## Appendix A

### Response to Submissions

#### Department of Planning, Industry and Environment (DPIE)

Figure 2: Updated Land Use Zone Figure (Source: Western Parkland City Precincts SEPP)

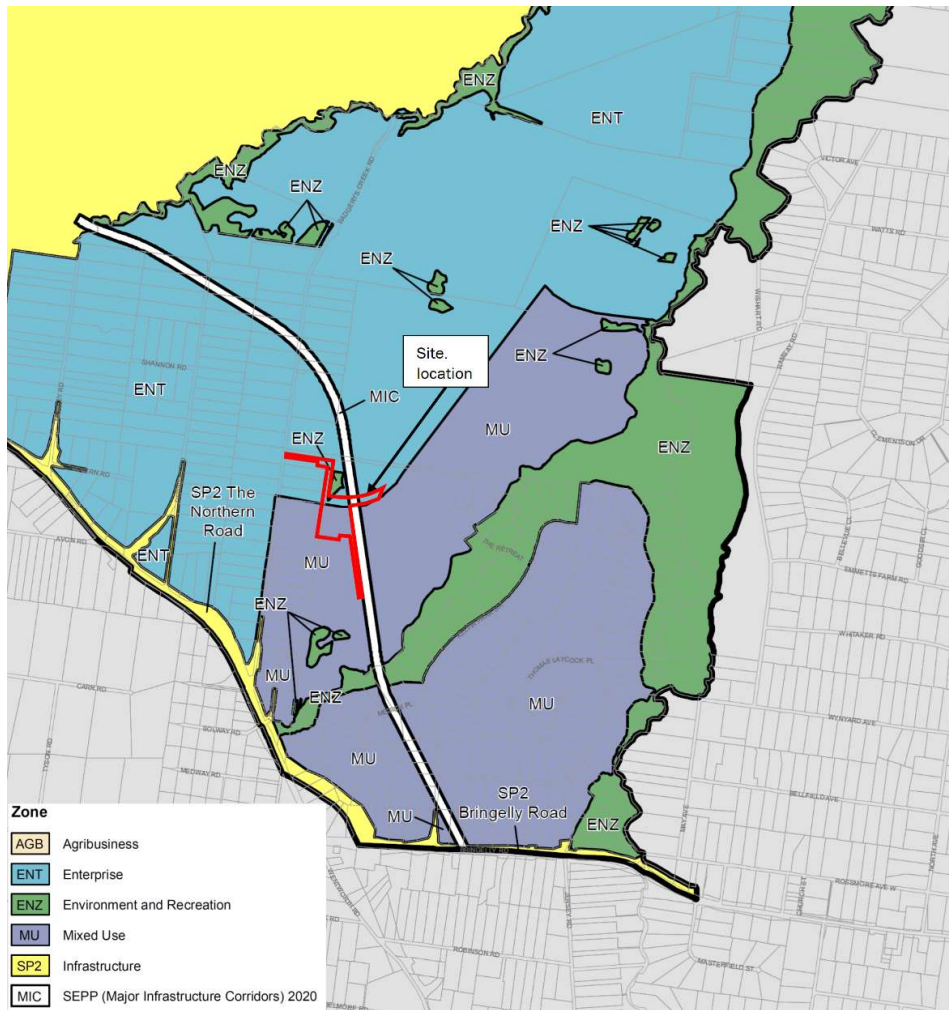
<p><u>Reporting of zoning and land use permissibility in the EIS</u></p> <ul style="list-style-type: none"> <li>• Page 31 of the EIS does not recognise the SP2 Infrastructure zoning of the MIC which traverses the development site. Please clarify.</li> </ul>	<ul style="list-style-type: none"> <li>• The land zoning map in the EIS (Figure 13) shows the land use zones under the Aerotropolis SEPP, which notes the area of land</li> </ul>

DPIE Industry Assessments	Comment/Response
<ul style="list-style-type: none"> <li>Page 35 of the EIS includes the zoning map for the MIC under the MIC SEPP but incorrectly identifies the development site, with the map showing an 'approximate site location' adjacent to the corridor (see below screenshot). As noted above, the architectural plans should be updated to identify the MIC.</li> <li>Provide details of the land use permissibility of works within the SP2 corridor.</li> </ul>	<p>on which the MIC SEPP applies. Under the MIC SEPP, this land is zoned SP2.</p> <ul style="list-style-type: none"> <li>The Aerotropolis SEPP is now repealed by the <i>State Environmental Planning Policy (Precincts—Western Parkland City) 2021</i> (Western Parkland City Precincts SEPP).</li> <li>The EIS erroneously states the First Building is wholly within the ENT – Enterprise zone, however the only components of the project within this zone are the roads and associated infrastructure that are ancillary to the building.</li> <li>An updated land use zone figure is provided in Figure 2.</li> <li>The AMRF First Building site is located on land zoned MU - Mixed Use and as a "High Technology Industry," the proposed development is permissible with consent in the MU zone.</li> <li>The only works associated with the development within the MIC (SP2 zone) is the temporary access road connection with the Metro access road. Roads are permissible with consent in the SP2 zone.</li> </ul>

Figure 3: Salinity potential First Building site (Source: ERM 2021)

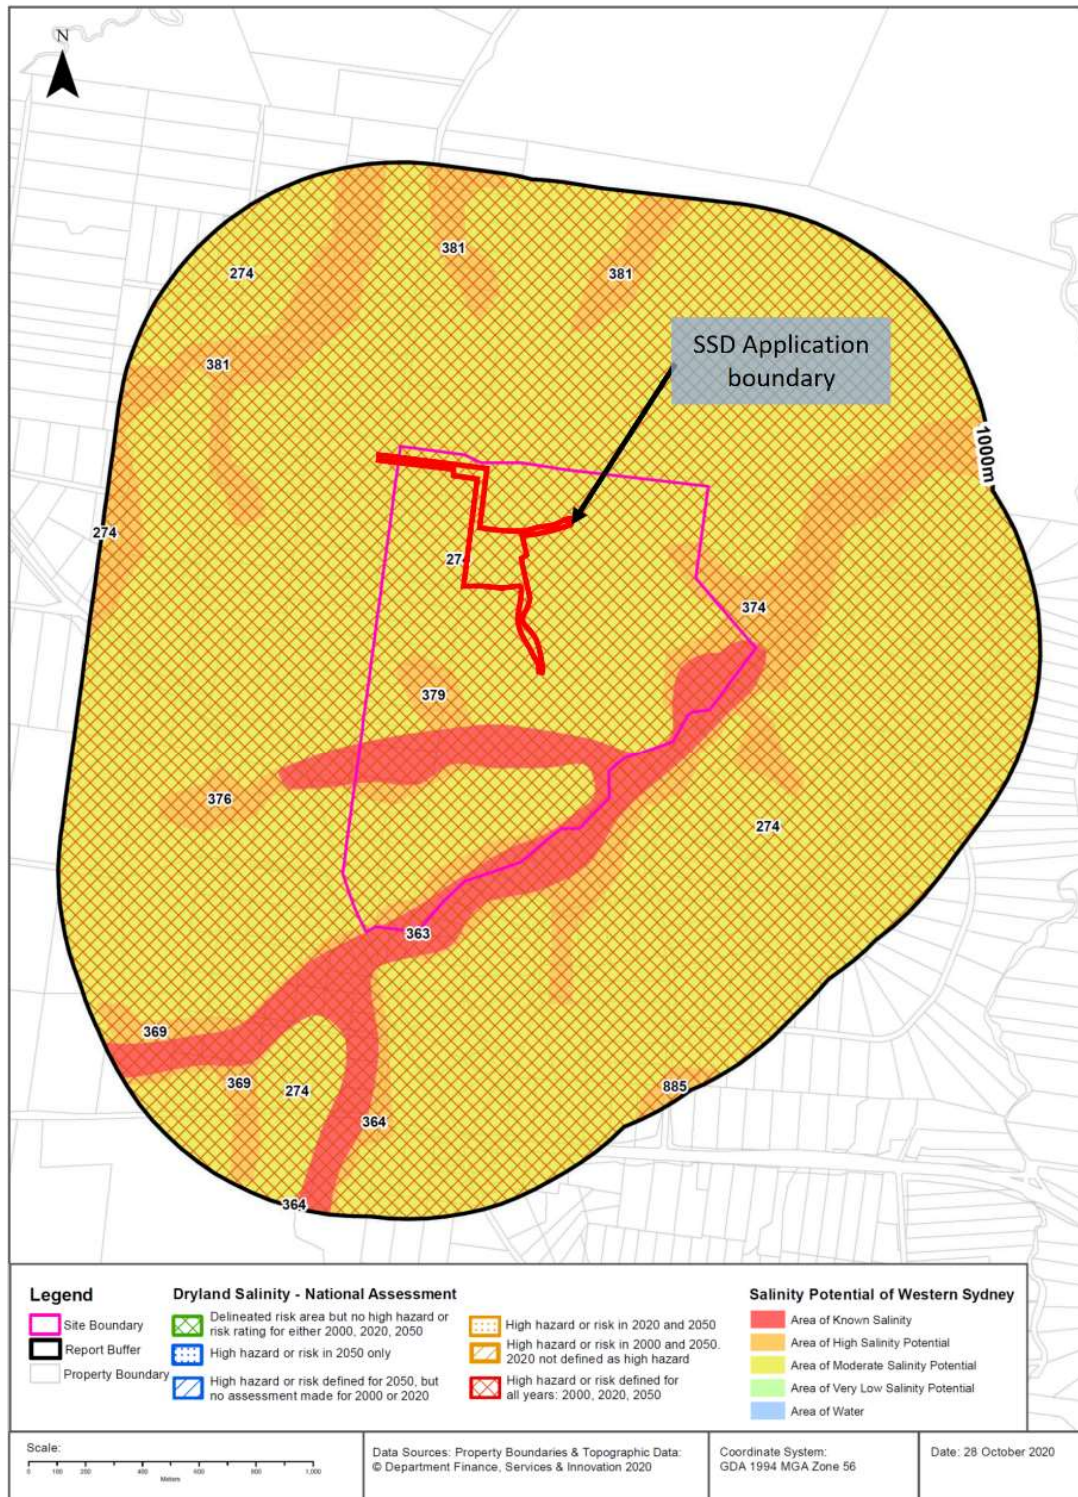
DPIE Industry Assessments	Comment/Response
	<p>our earlier advice on mainstream flooding, as detailed in our report for the SSDA dated 15th November 2021.</p> <ul style="list-style-type: none"> <li>• Consequently, Advisian has advised that there is no risk of inundation of the First Building Site from flooding of Moore Gully or Thompsons Creek</li> <li>• Based on the Dryland Salinity Map in the <i>Aerotropolis Core Precinct Review of Contamination Issues</i> (ERM, 2021) shown in Figure 3, the site is located in an area of 'Moderate Salinity Potential.'</li> <li>• Discharge from the site will be directed via on site detention basins with controlled release towards Thompsons Creek, which is denoted an area of 'Known Salinity'</li> <li>• Given the site discharge will not be directed from an area of higher salinity to lower salinity, the proposed development would not increase the salinity hazards across the site (consistent with principle PO8 in Section 4.3.2 in DCP Phase 2).</li> </ul>

Figure 4: Site access arrangements (Source: AECOM)

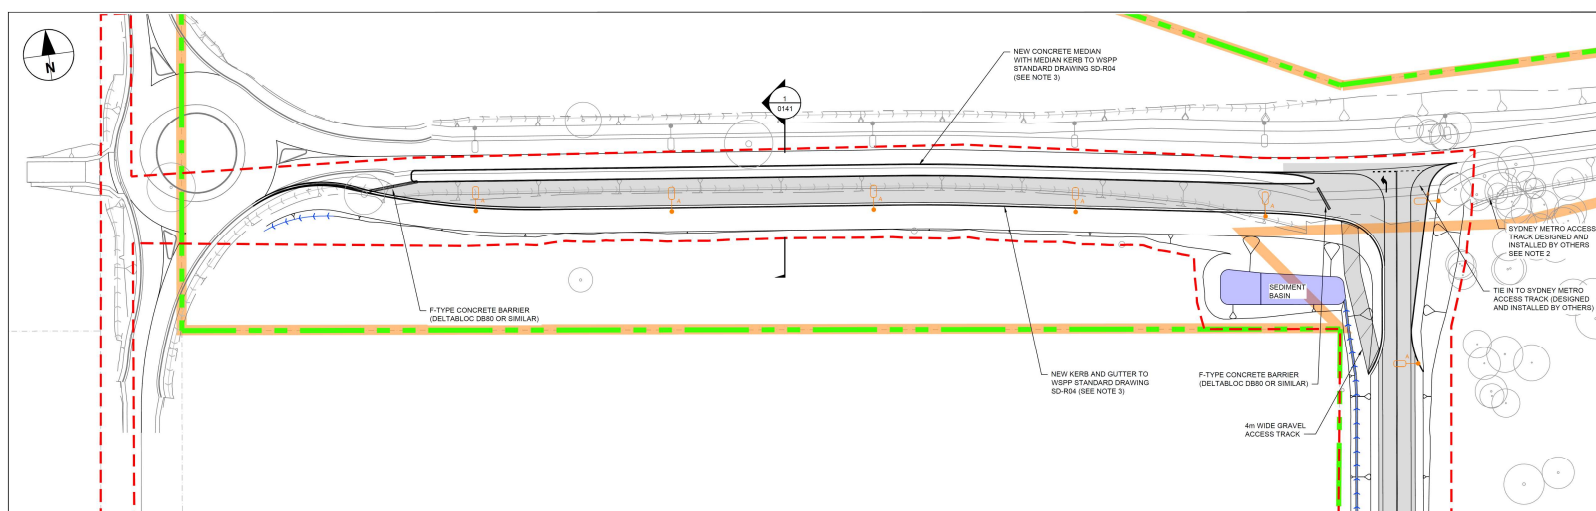
DPIE Industry Assessments	Comment/Response
<b>14. Traffic</b> <ul style="list-style-type: none"> <li>Clarify access arrangements with the construction access road and connection with the Sydney Metro construction access road</li> <li>Confirm whether WPCA is delivering the remaining half road construction on the pan handle access and if this is going to be completed and operational prior to commencement of operation of the First Building</li> </ul>	<ul style="list-style-type: none"> <li>An extract of the civil plans (Appendix I) showing the access arrangements is provided in Figure 4 below.</li> <li>WPCA is delivering the construction access road which will be completed prior to commencing operation of the First Building</li> </ul>

Figure 6: Extract p 13 Architectural Design Report (Hassell)

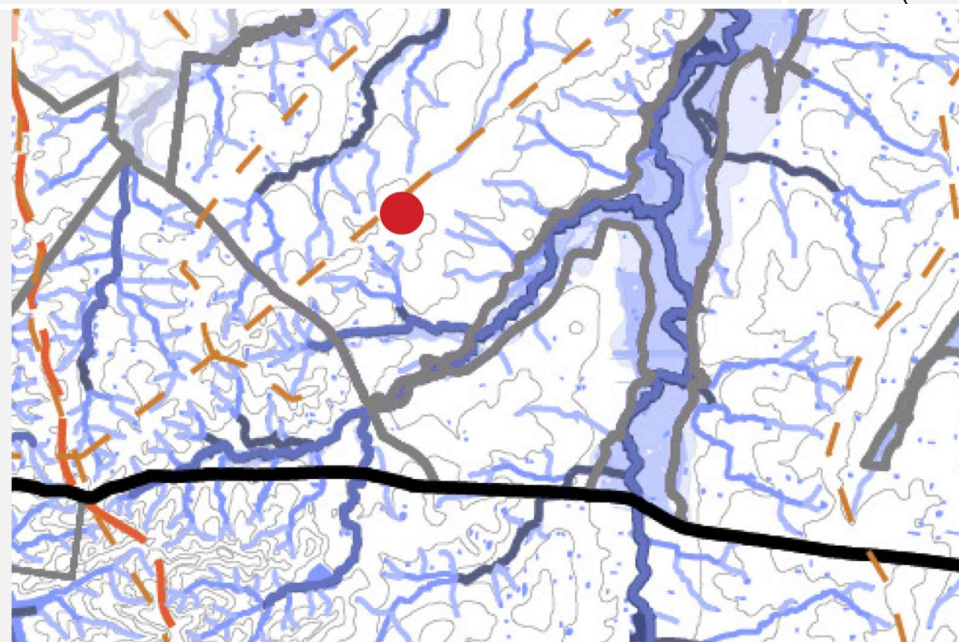
Council comments	Comment/Response
<p>The civil/architectural/landscaping plans do not identify the existing Strahler order streams on the site and do not identify how the proposal is to achieve the vision of the WSAP in this regard.</p>	<ul style="list-style-type: none"> <li>• Further regeneration of the area to the north of the First Building and 15<sup>th</sup> Avenue will be undertaken in the future and dealt with through the master plan.</li> <li>• As indicated on page 13 of the Architectural Design Report (extract provided in Figure 6 below), the site is located on the ridge and does not intersect riparian corridors, creeks or streams, particularly those identified in Figure 5 of the Precinct Plan (Strahler 2 and above).</li> </ul>

Figure 10: Site location in relation to Figure 6 of the Precinct Plan

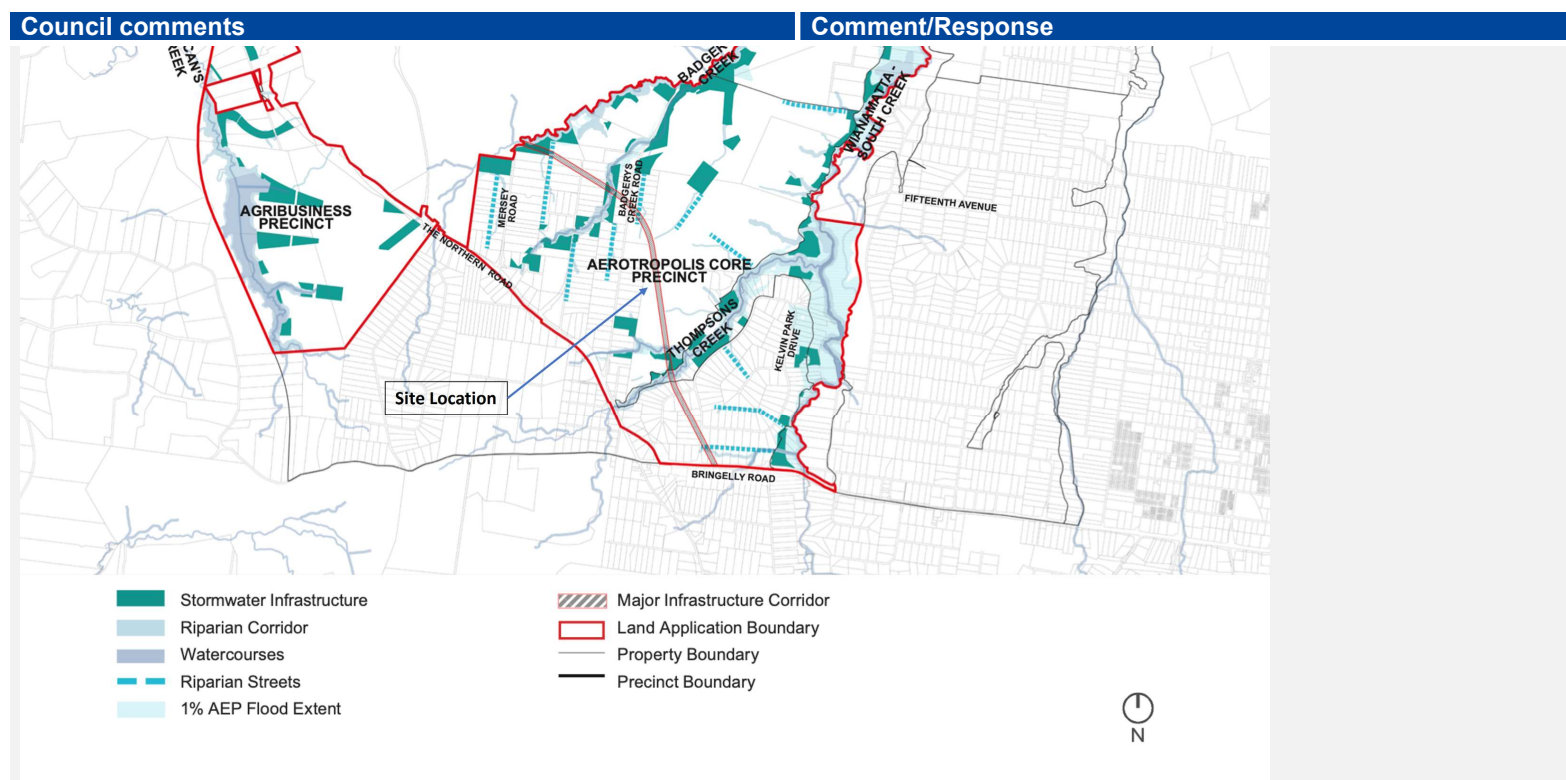
BG03 Establish a network of multifunctional stormwater assets that support stormwater management and contribute to broader objectives for waterway health, biodiversity, urban greening and cooling, recreation and amenity.	<ul style="list-style-type: none"> <li>• The multifunctional stormwater assets are intended to service the broader Aerotropolis as shown in Figure 6 of the Precinct Plan (Figure 10).</li> <li>• These are yet to be established and are not relevant to the First Building proposal.</li> </ul>

- The First Building stormwater infrastructure has been designed to align with the performance outcomes in Performance Outcome 2 in Section 4.3.2 in the DCP Phase 2 Draft (Oct 2021).
- AECOM confirms it has designed the infrastructure around the First Building to tie into a future masterplan to be designed in accordance with the Precinct Plan (as issued in March 2022 – following submission of the SSDA Design in November 2021).
